Project: IEEE P802.15 Working Group for Wireless Personal Area Networks (WPANs)

Submission Title: Comment Resolution CID 3060, LB-101

Purpose: Comment Resolution for CID 3060 of LB101

Illustration of RX duty cycling:

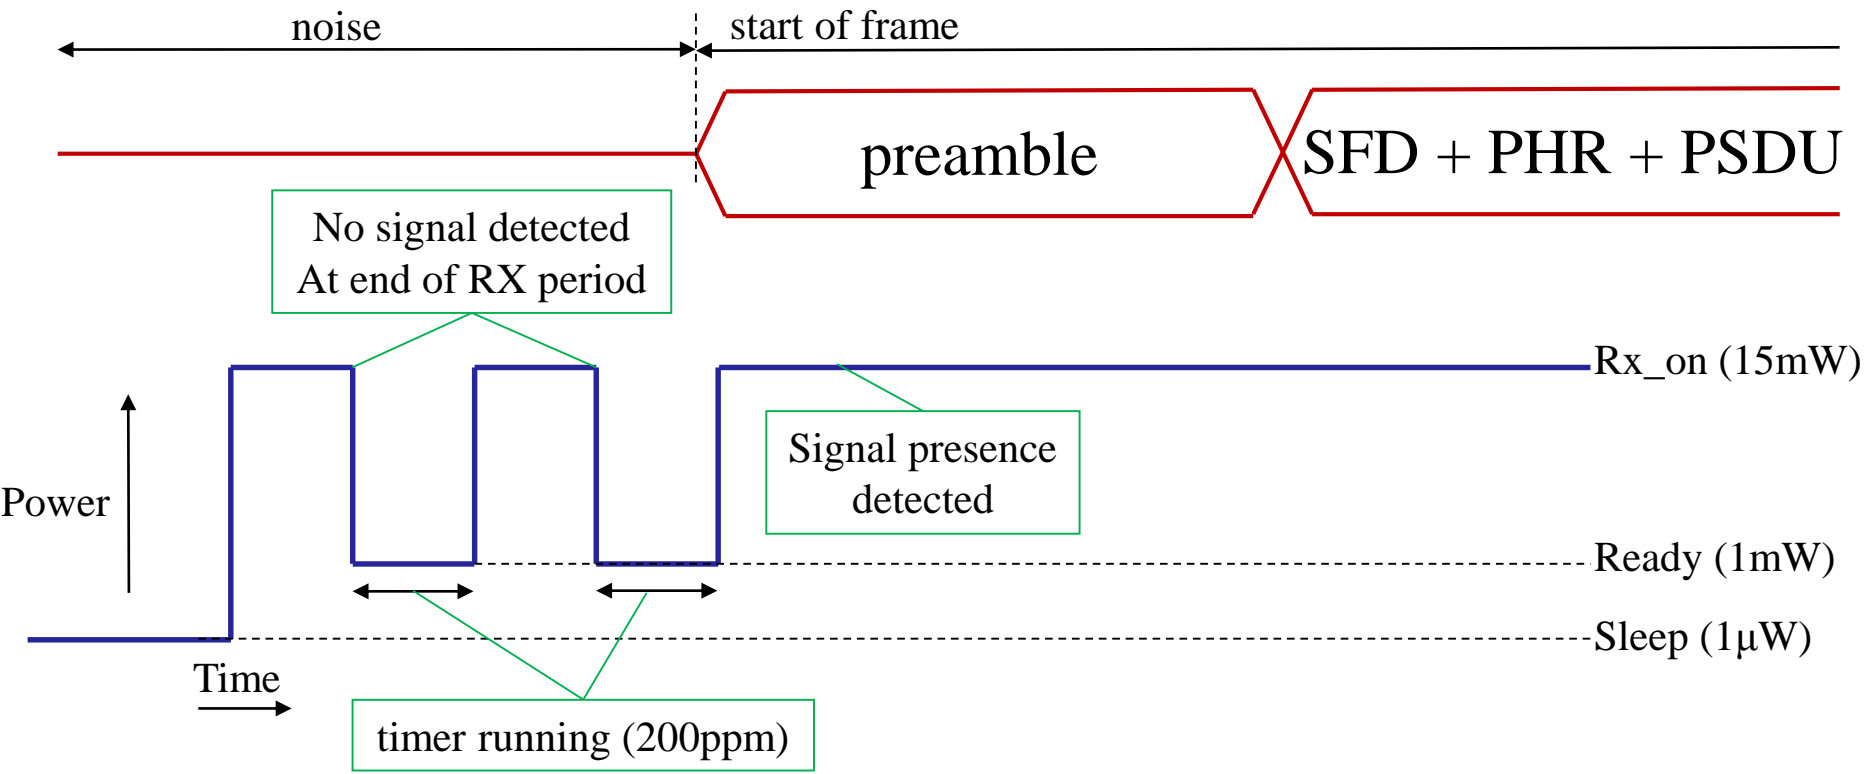
Allowing a variable preamble length in 15.4g was a bad compromise that should not be repeated. The response “The optimal preamble length depends the use case. E.g. when battery life is limited by TX power consumption a short preamble is preferred.” is incorrect. First, the short preamble would save only a little bit of energy and only if the channel at that moment allows it. Furthermore, requiring an implementation to support a short preamble complicates the design (requiring faster AGC, DC offset removal, etc.) that will require more power in the receiver. Devices typically spend more time receiving rather than transmitting and so making the receiver more difficult and power hungry is a bad idea.

Set the preamble length to be 4 octets, fixed. 2 is too short and 4 is sufficient.

Revised: Have a fixed preamble length: 8 Bytes for beacon frames and 4 Bytes for all other frame types. Remove phyUlpGfskPreambleLength and references from the draft. Replace all text in 31.1.1 with "The preamble field of any beacon frame shall contain 8 multiples of the 8-bit sequence "01010101". In all other frame types the preamble field shall contain 4 multiples of the 8-bit sequence "01010101".

- Fixed definition allows for performance optimization
- Longer preamble in beacon allows for receiver duty cycling

A longer preamble allows the receiver to be duty cycled without missing the beacon.
E.g. 16 bits RX on. Go to a low power mode (Ready) when no signal is found for 24 bits.
